Title: Dock unit Typical
Client: Maple Grove owners Assn.
PO Box 1630
Port Angeles, WA 98362

12 October, 2016

Subject: Dock Anchor inspection

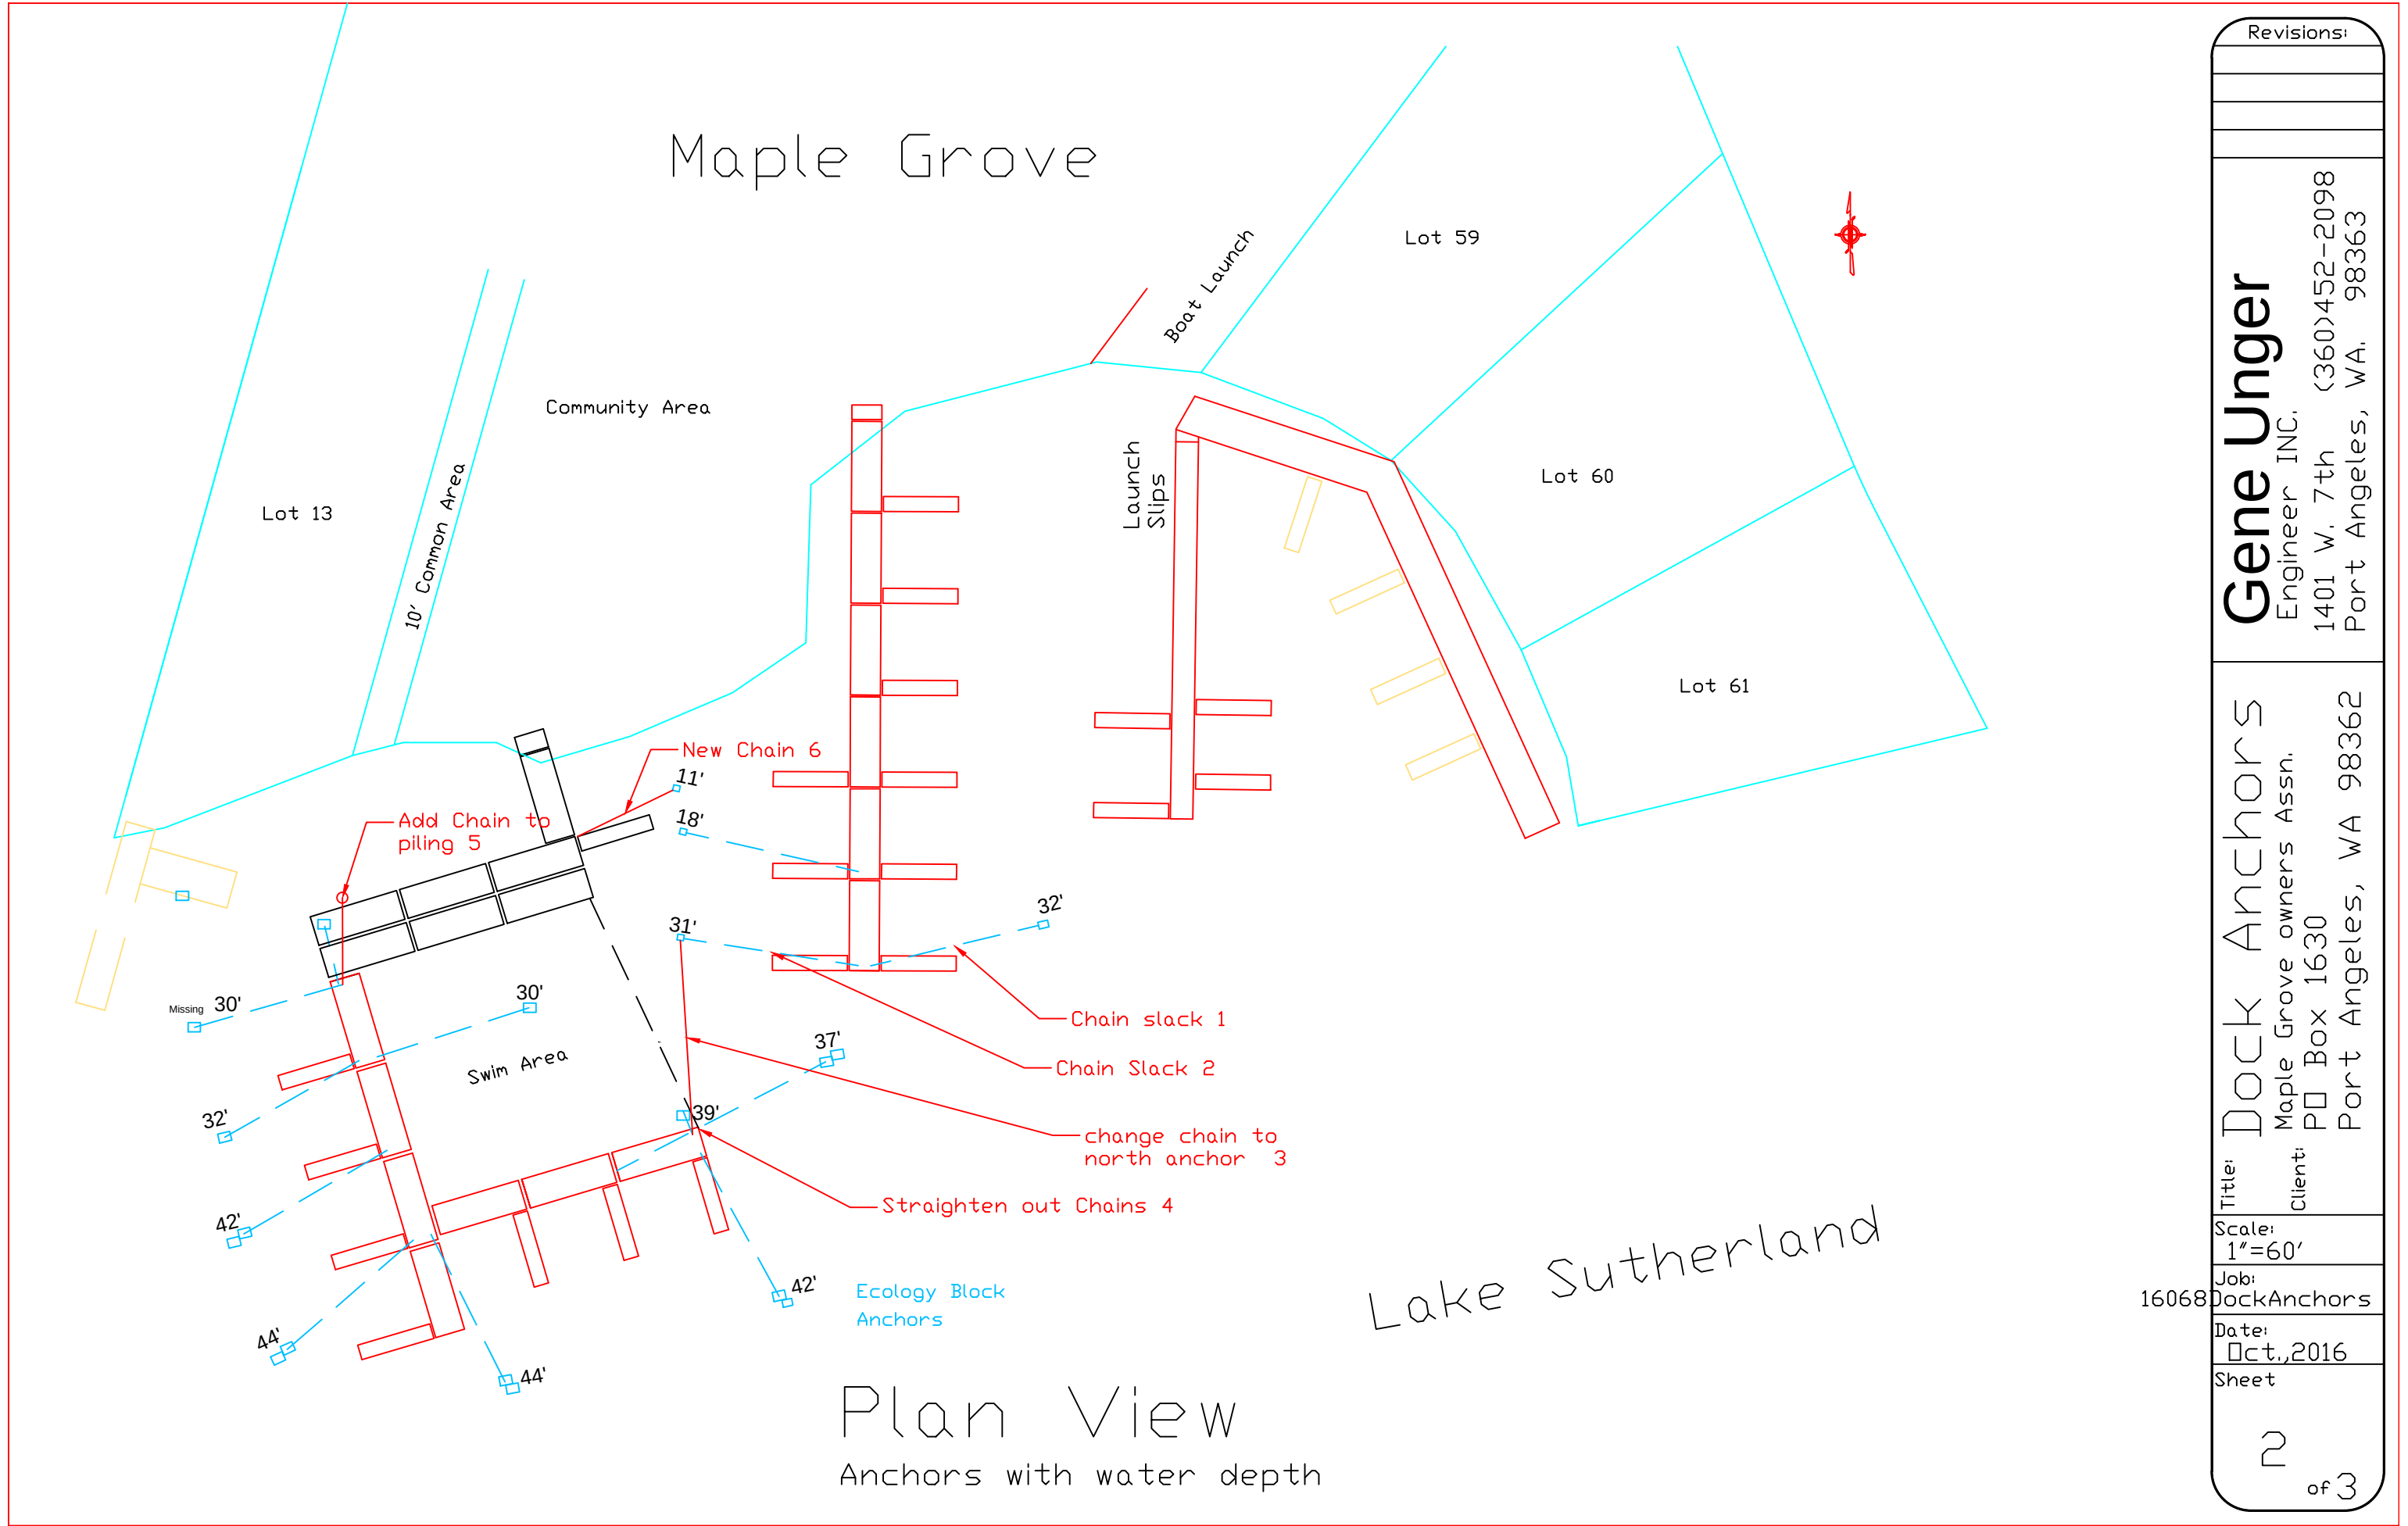
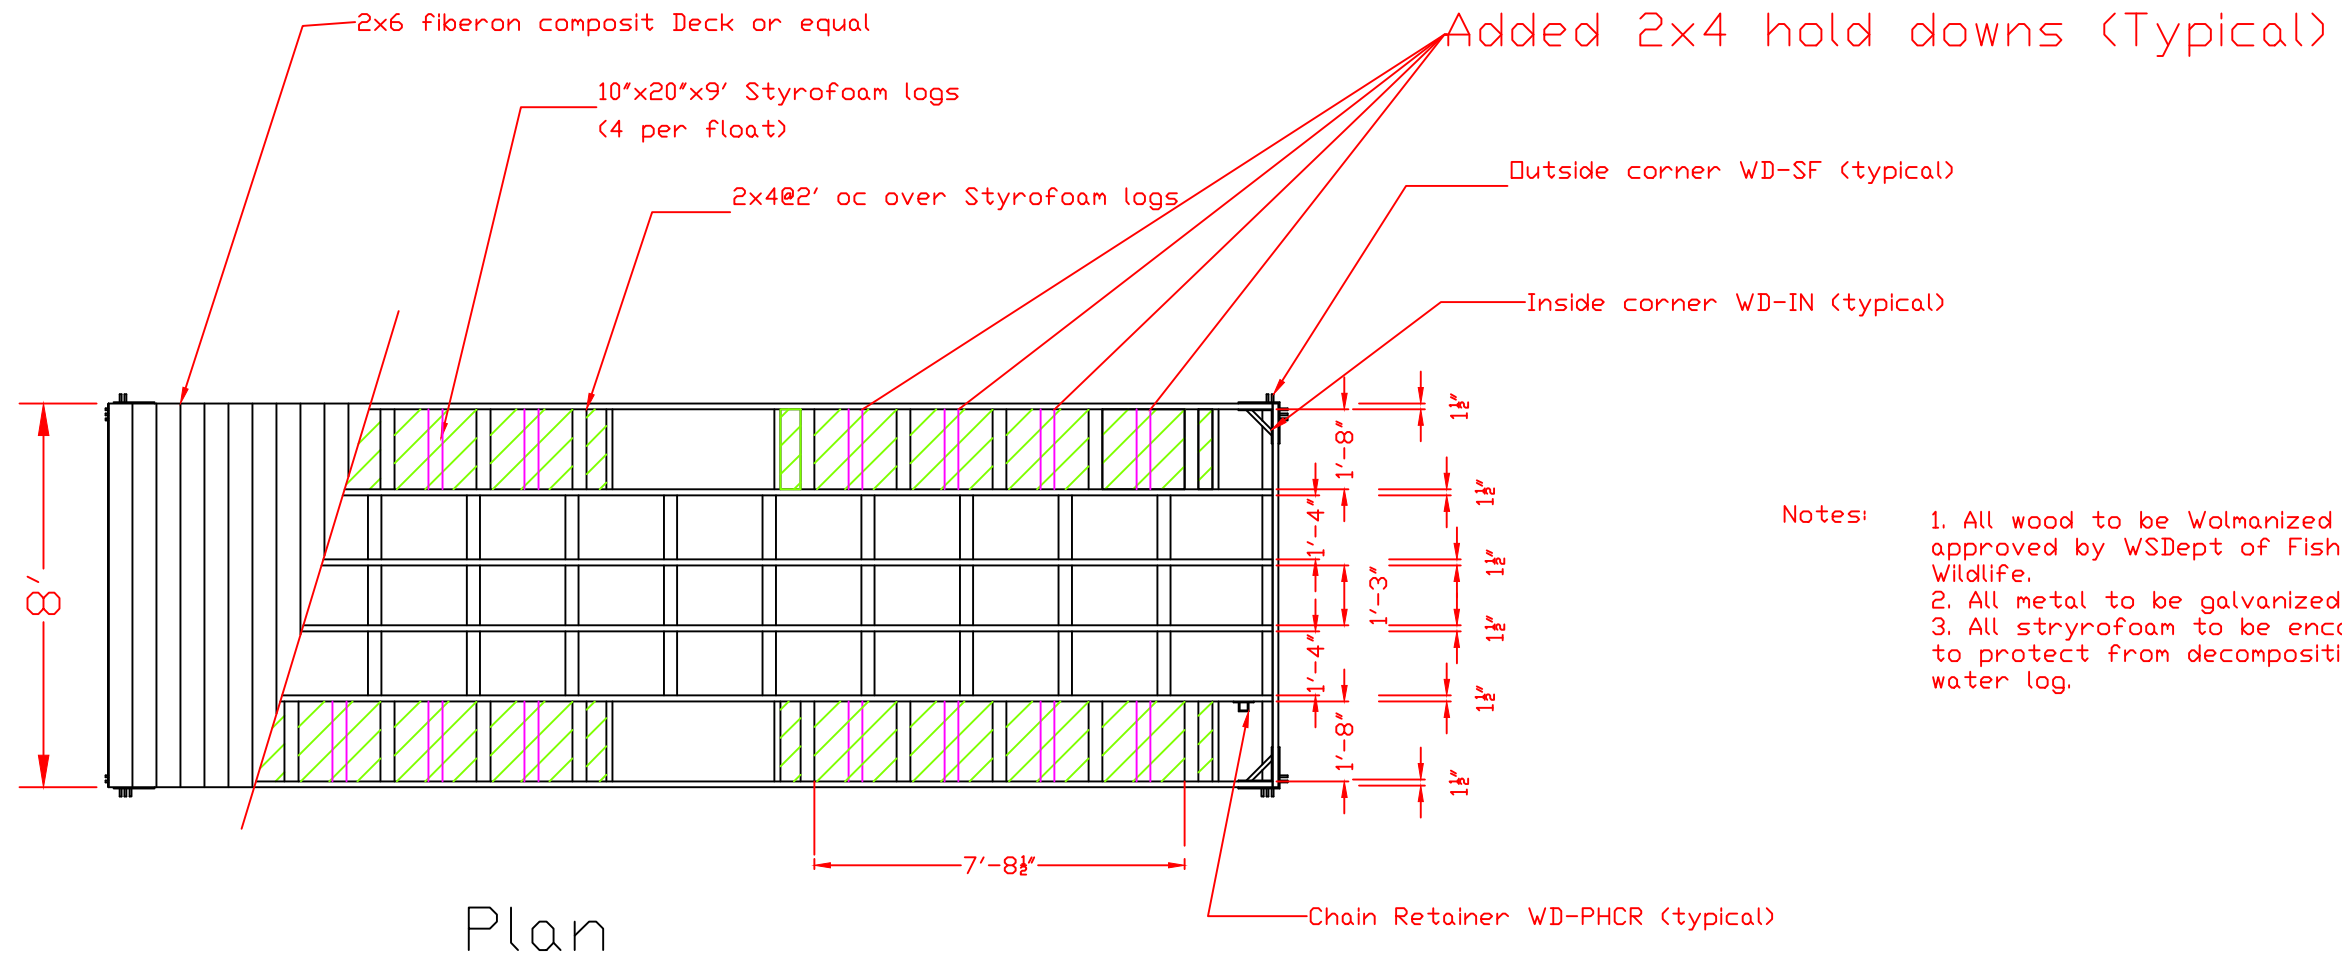
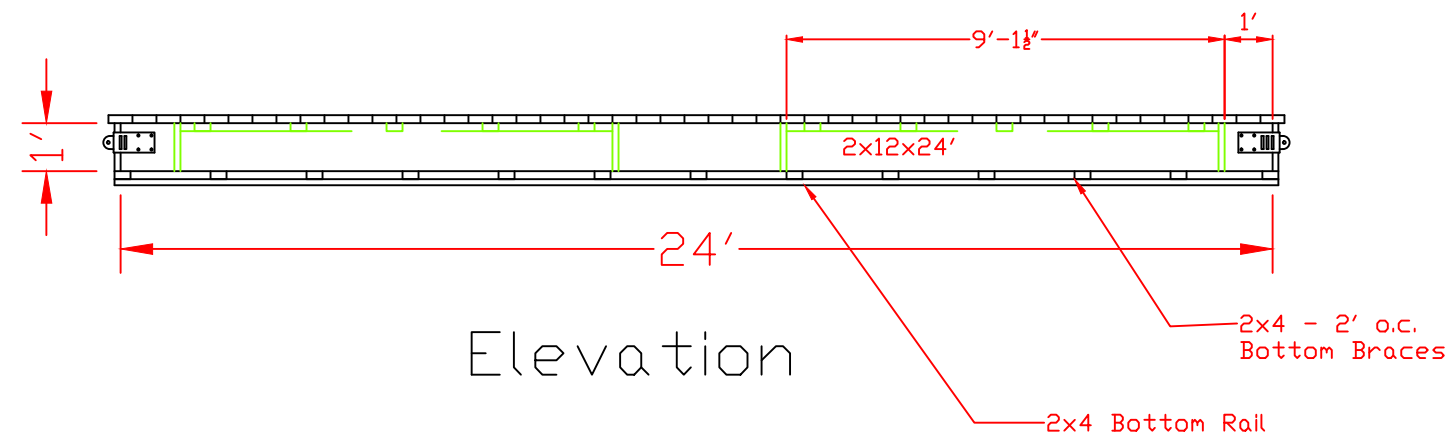
When this is done it will be time to work on the six north docks of the "C" pier. They need to have the decking removed and have additional 2x4 hold downs for the floats installed. This is most essential to the northeast dock and the southwest dock of the six north docks. Presently the floats are receiving enough wave action that they have worked the present five 2x4's, holding them down, loose so that they are lifting the decking off the dock. The added hold downs shall be installed using 4"x#8 Stainless screws through the stringers. An angled screw holding the 2x4 down should also be installed at each end of the 2x4's into the stringers. The decking can then be installed as it was originally.

I expect that with this work completed on the dock they will basically back in good floating condition. At this time it will be time for the owners to consider a deck replacement program. I would suggest replacing the decking on one dock unit at a time. The existing wood is showing its age and the float logs can be cleaned as the decking is replaced. The new decking needs to be treated by WS Dept. of Fish & Wildlife treatment and installed with 3"x#8 stainless screws or greater.
